PRELIMINARY ENGINEERING
IMX-080-3(315)128--02-77
POLK COUNTY

PLANS OF PROPOSED IMPROVEMENT ON THE
PRIMARY ROAD SYSTEM
POLK COUNTY
PRELIMINARY ENGINEERING

I-35/80 from IA 141 in Urbandale to E of I-35/80/235
 Northeast Mixmaster System Interchange (NEMM)

FIELD EXAM CHECKLIST

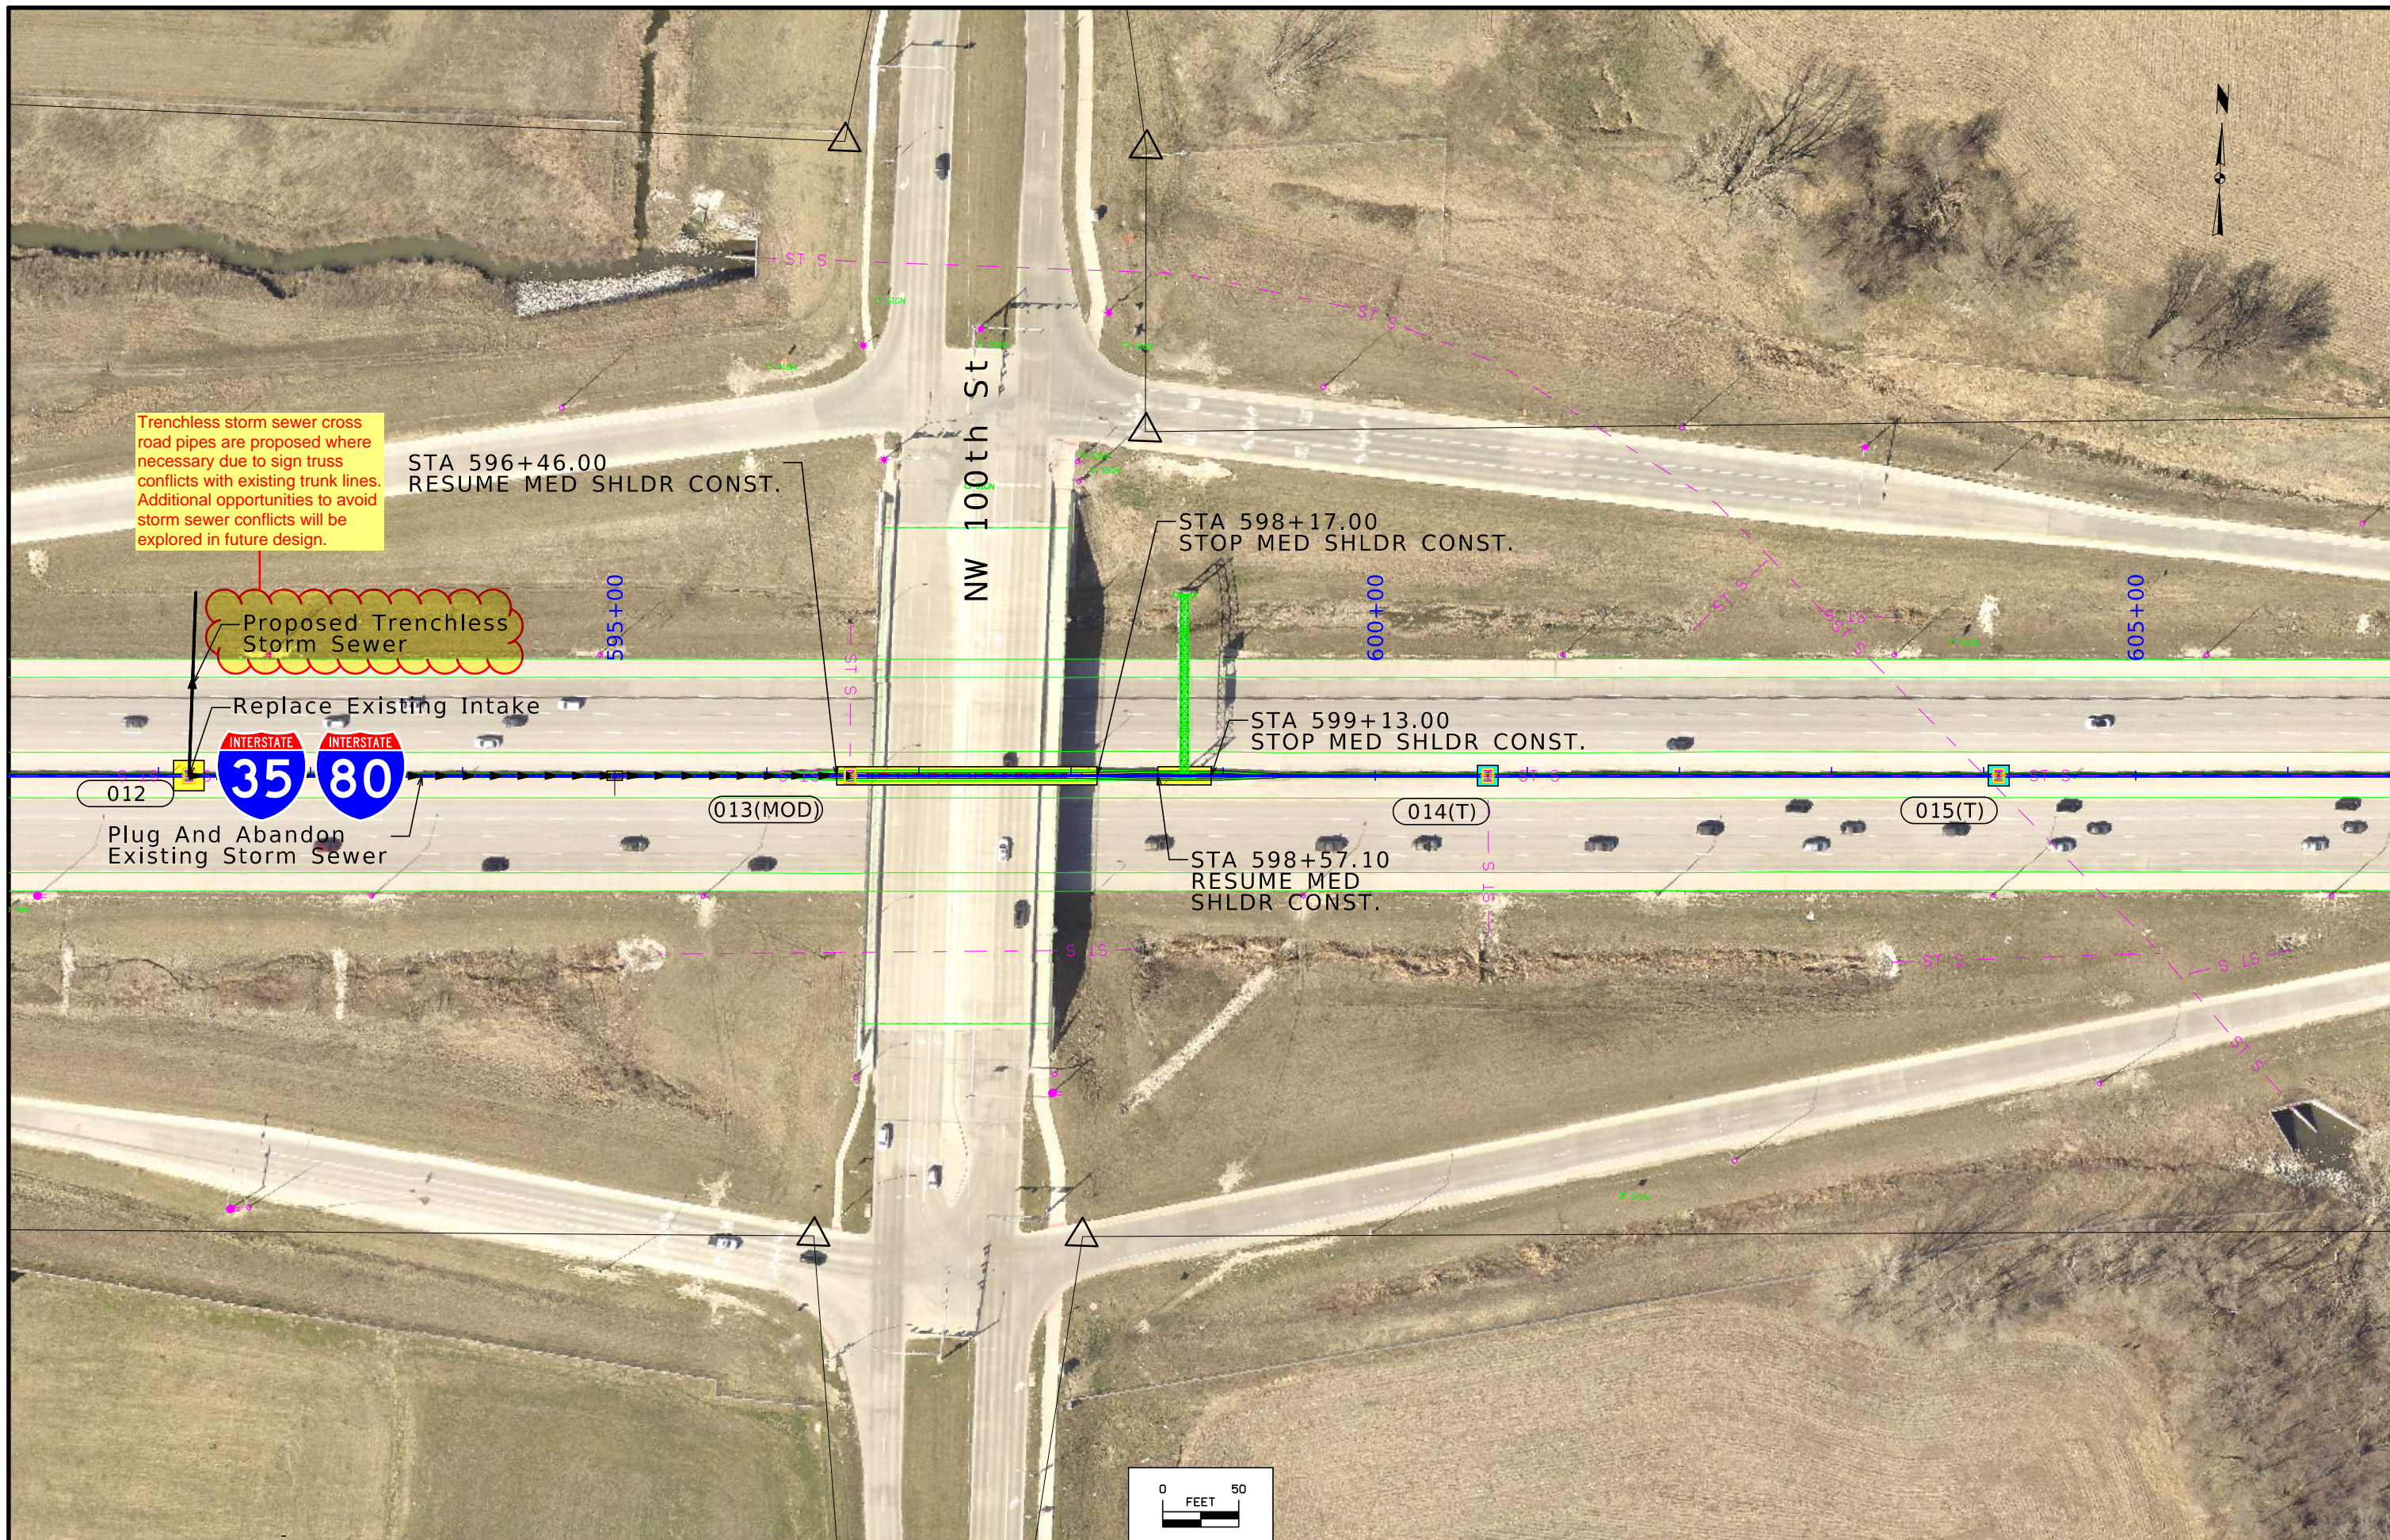
While outside DSU lane, intake tops will be fastened due to proximity of traffic.

Trenchless storm sewer cross road pipes are proposed where necessary due to sign truss conflicts with existing trunk lines. Additional opportunities to avoid storm sewer conflicts will be explored in future design.

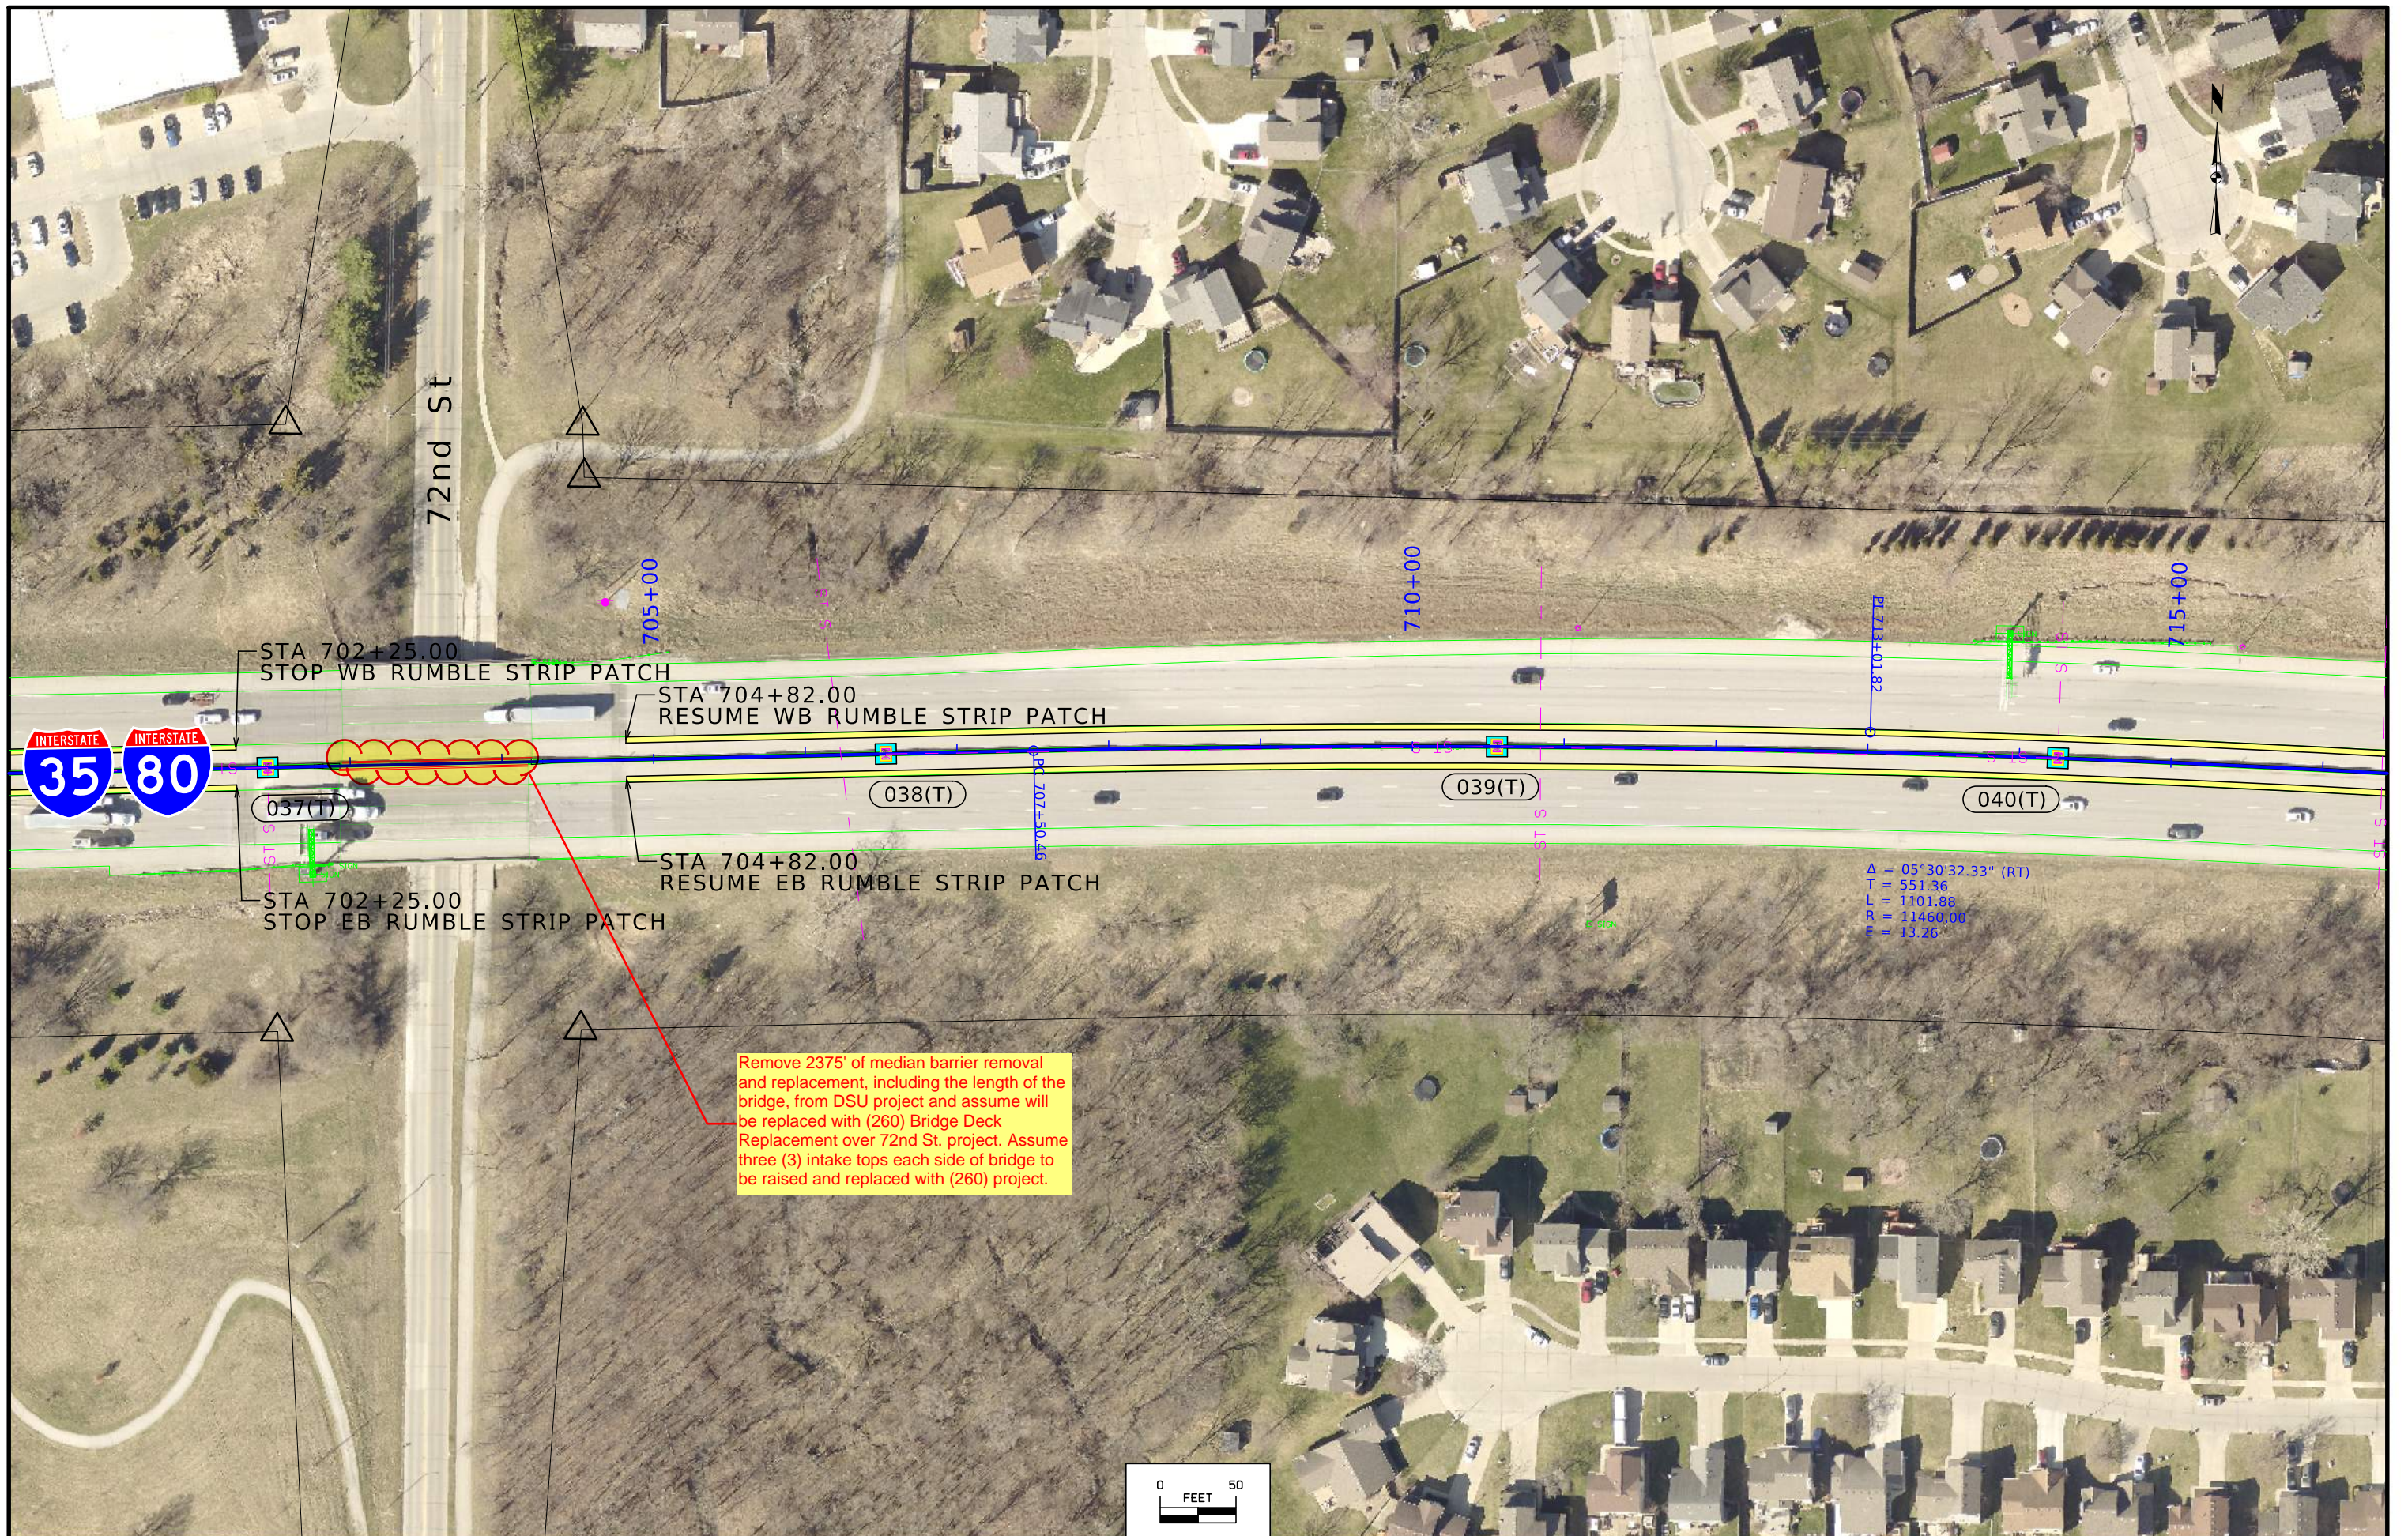
Remove 2375' of median barrier removal and replacement, including the length of the bridge, from DSU project and assume will be replaced with (260) Bridge Deck Replacement over 72nd St. project. Assume three (3) intake tops each side of bridge to be raised and replaced with (260) project.

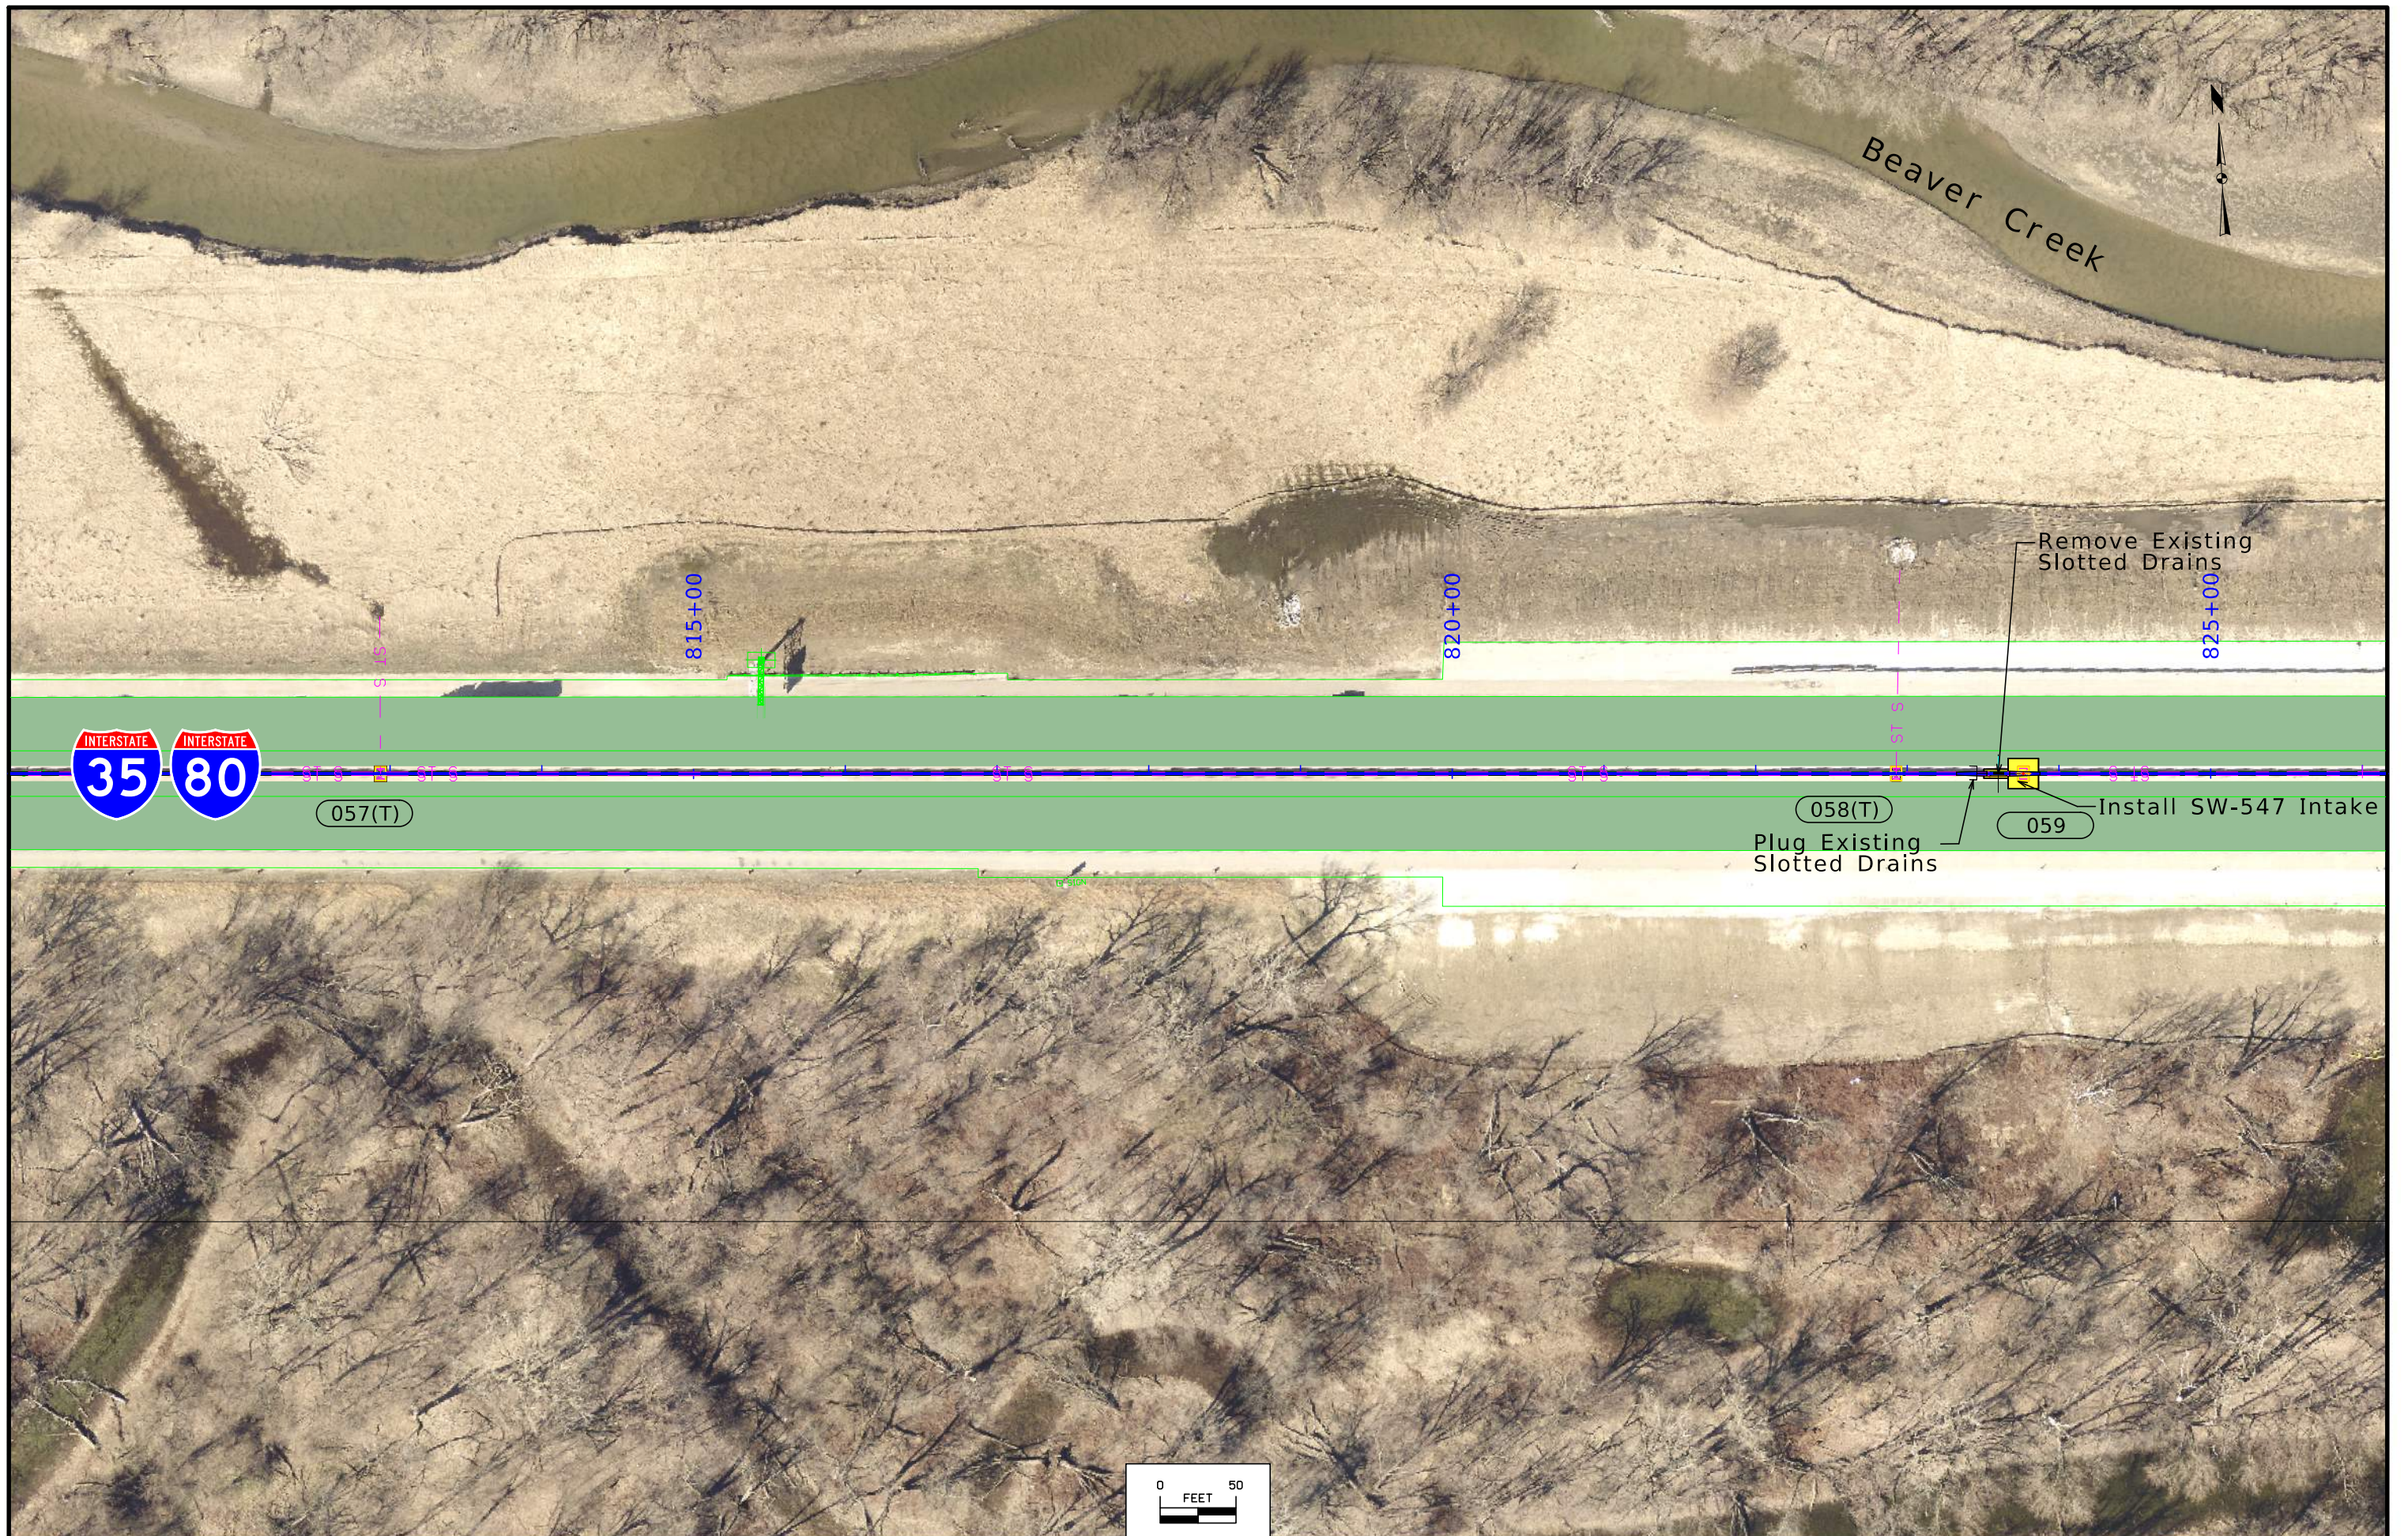
Remove Existing Slotted Drains
And Install SW-547 Intakes
Either Side Of Sign Truss
